Horace Mann Addition/Renovation Project

DRC Project Update		
Date:	Wednesday, January 10, 2024	
Date:	Zoom Meeting (online)	
Time:	7:30PM	
Attendees:		
See attached Sign-In List for Design Review Committee, City Staff and Project Teams as well as Community members who were in attendance.

Linwood Avenue Access Drive

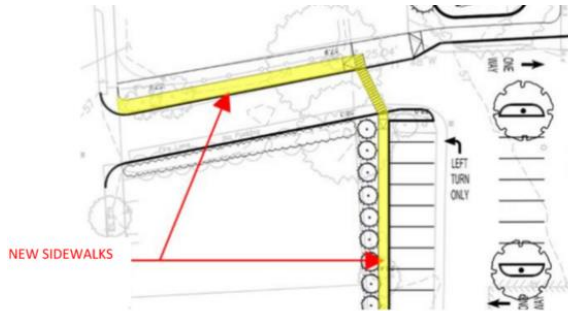
An image was presented showing the current condition of the school with a narrow 2-way access road off Linwood Avenue. There is no existing sidewalk with a striped pathway guiding pedestrians from Linwood Avenue through the parking lot. At recent Working Group meetings, RDA presented four (4) different options with the preferred recommendation presented tonight (see image below).

The mature trees on both sides of the driveway present somewhat of a design challenge. RDA is working with Traverse (landscape architect) and Samiotes (civil engineer) to study a few different options.

A site plan and rendering were presented depicting a proposed sidewalk from Linwood Avenue, along the edge of the property, which would connect with existing walkways alongside the building.

Accessible Entrances

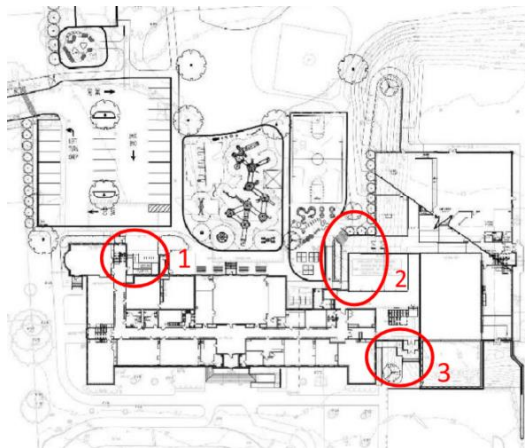
It was noted that per building code all entrances must be accessible. RDA reviewed with the HM school staff to determine which entrances need to be maintained as accessible. There are currently (3) exits at grade at the lower level. See image below for access locations.

A comment was made to consider a covering for protection from the elements, which would help to make the entrance safer.

A comment was made about the pathway from the cafeteria to the playground being too long. RDA will explore the option to incorporate an additional sidewalk on the opposite side of the basketball court to create a shorter, more direct route to the playground.

A new ramp and access door are proposed to be added at this location. The proposed door will replace an existing window. This entrance will allow the students to have an accessible entrance on the west side of the building. It has not yet been finalized whether existing access will be maintained or if it will be removed. RDA will explore options with the Working Group.
